ADDENDUM #2
ALLEN AVENUE SANITARY SEWER REPLACEMENT GP-1332 PART 1
14TH STREET WATERLINE REPLACEMENT PART 2
CITY OF CANTON

Friday, February 11, 2022

This Addendum is being issued to provide additional clarification on the plan sheets, additional information related to the project including plan notes and details, and to respond to questions submitted by Bidder's during the written question's submittal period.

14TH ST 8+00-12+00

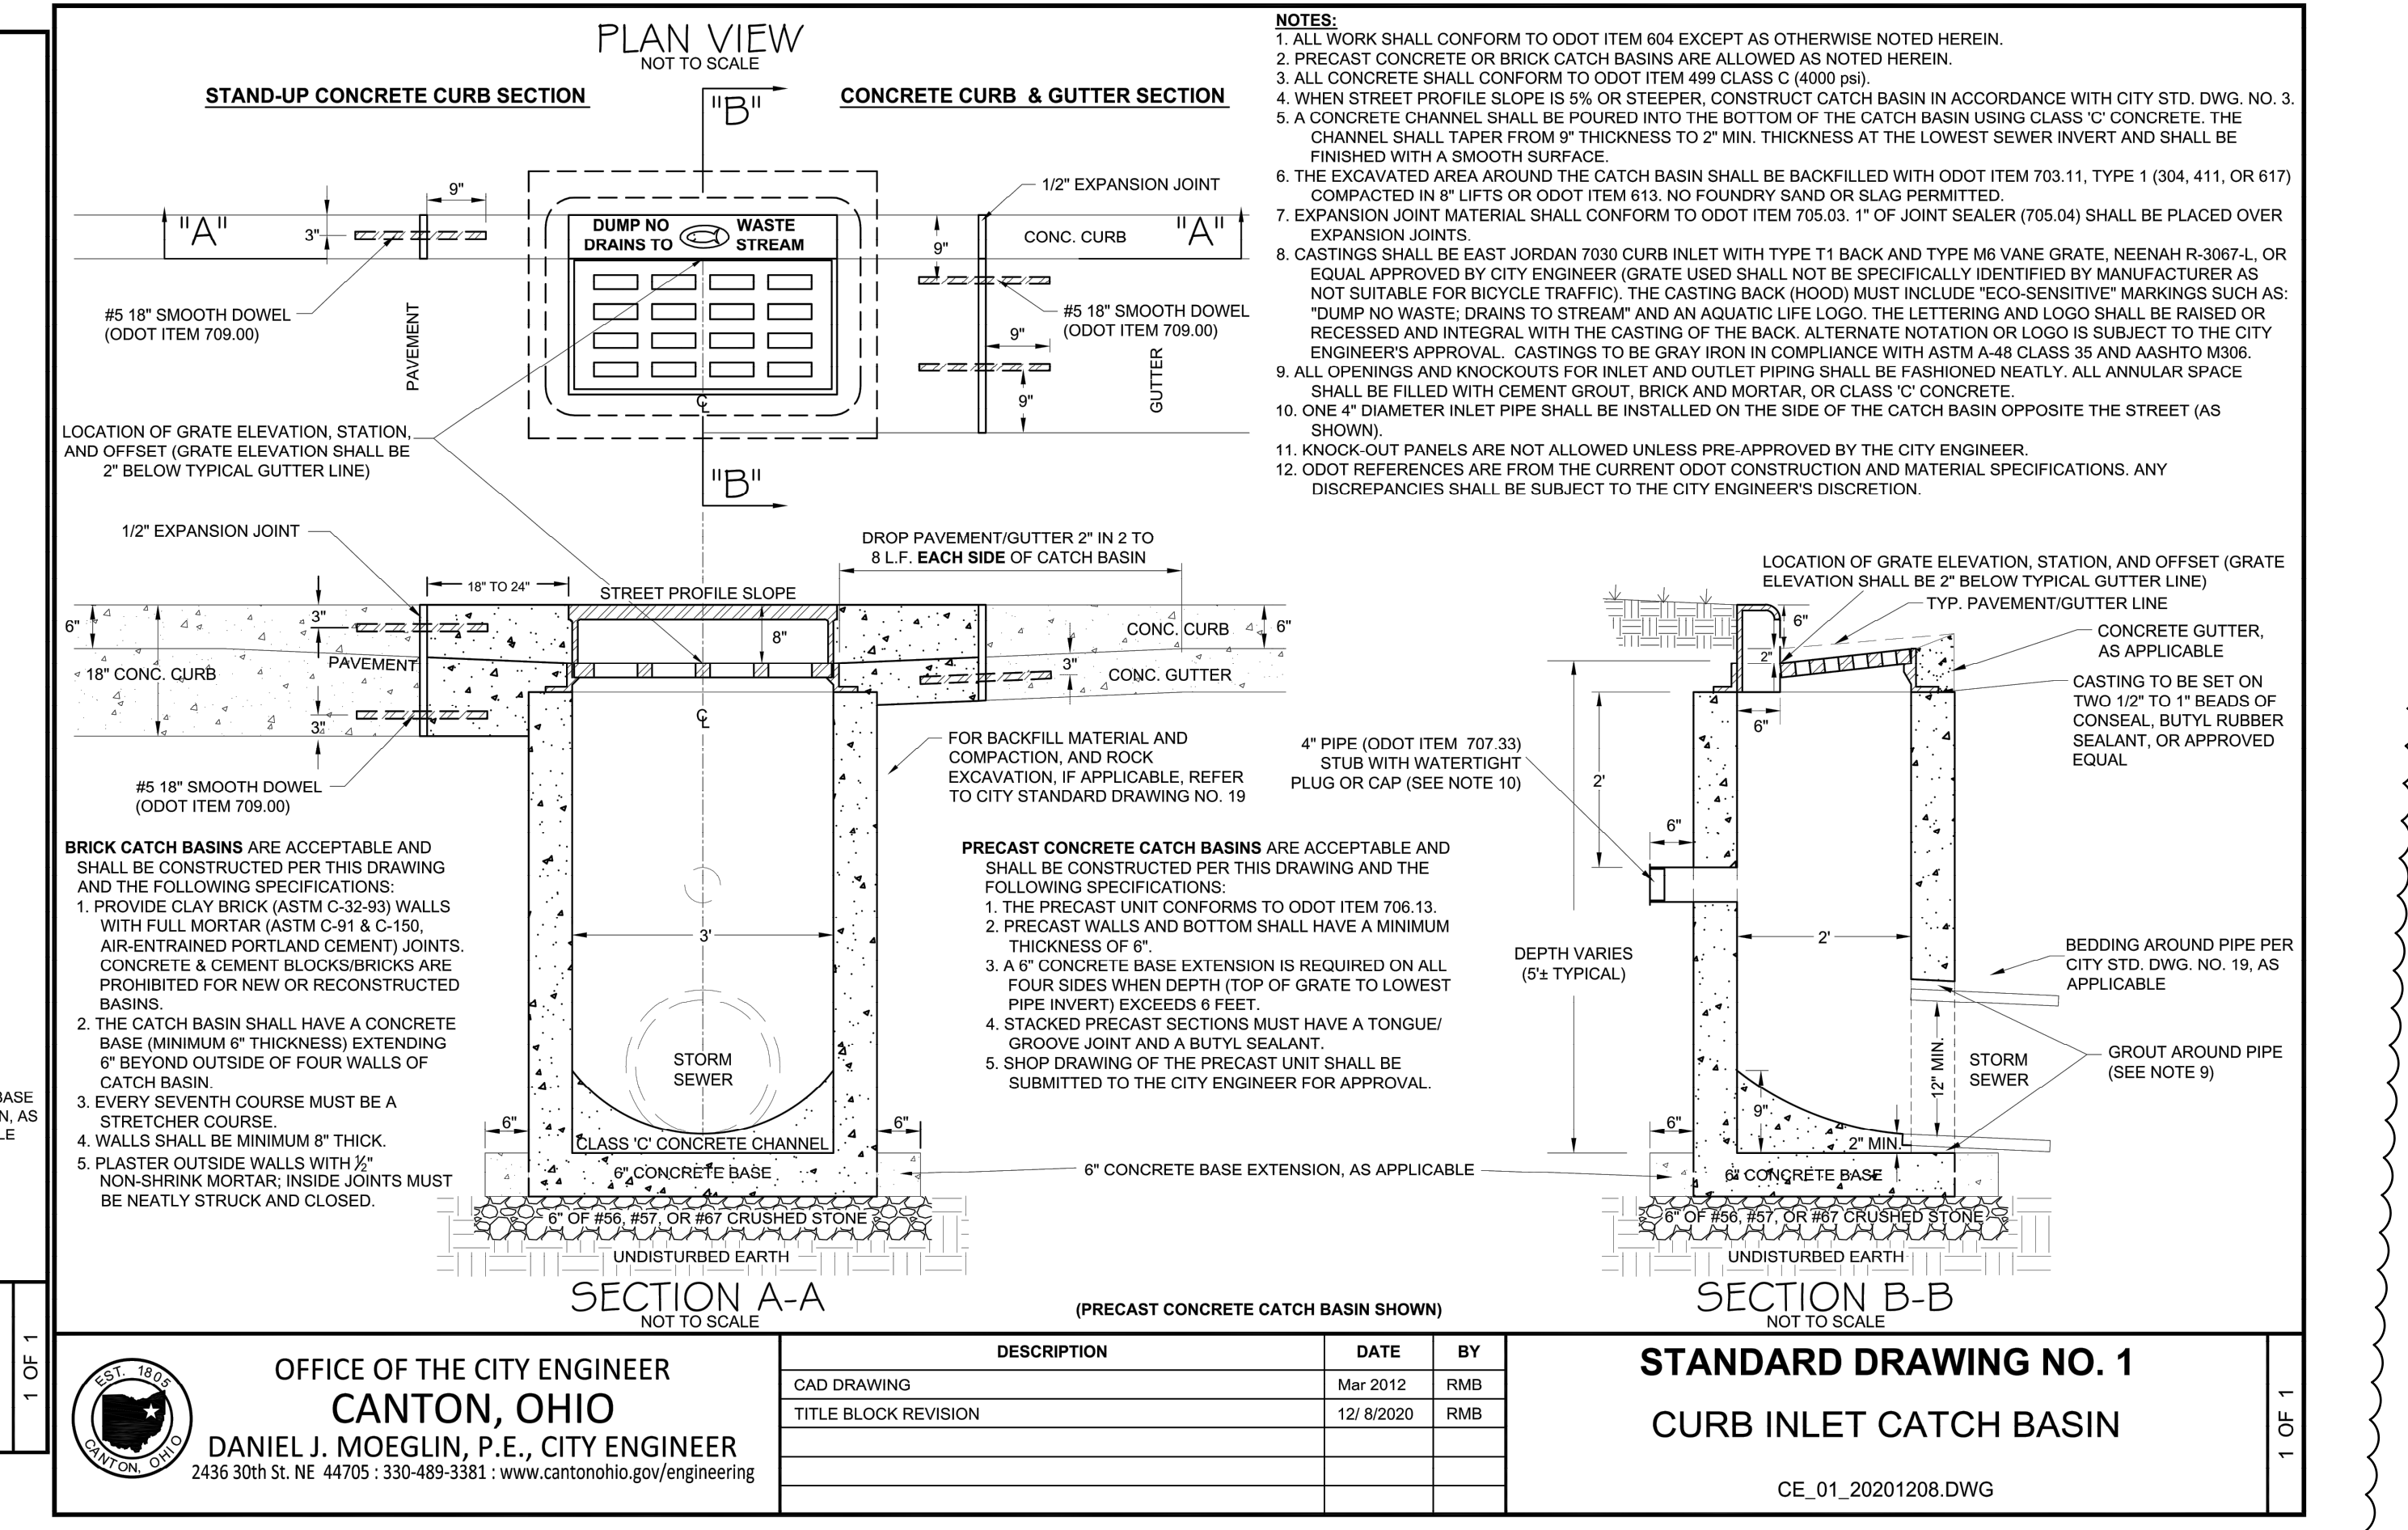
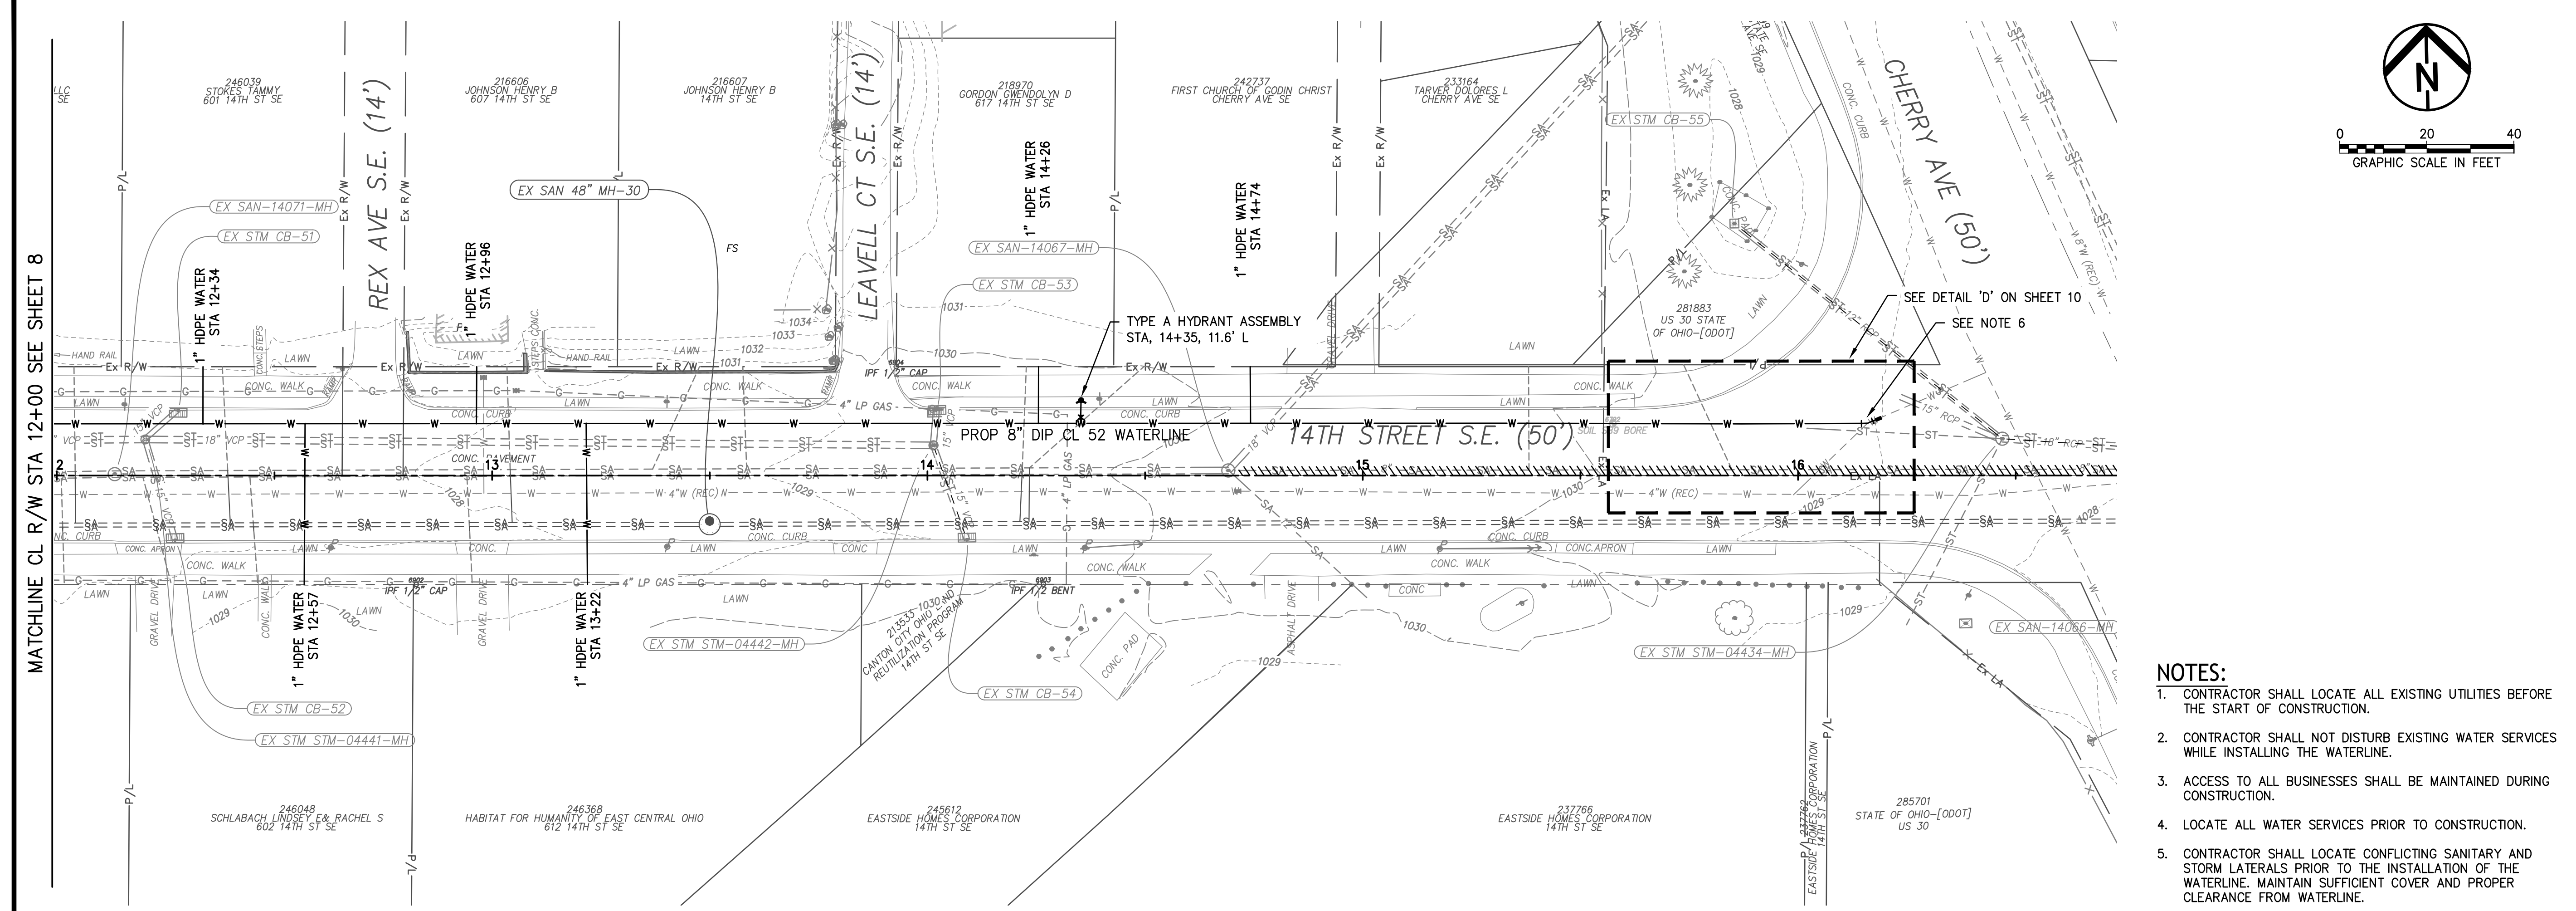
- E. On sheet #14 @ MH-5, the plans state to reconnect the existing 21" sanitary. Are we to include this work the manhole item? **The cost to reconnect the existing 21" sanitary shall be included in the provided bid items.**

1. CORE DRILL EXISTING MANHOLE STRUCTURE TO ALLOW INSTALLATION OF PROPOSED 10-INCH SEWER PIPE.
2. EXISTING 21" SANITARY SEWER IS TO REMAIN ACTIVE.
3. THERE SHALL BE NO PIPE JOINTS INSIDE THE EXISTING MANHOLE.
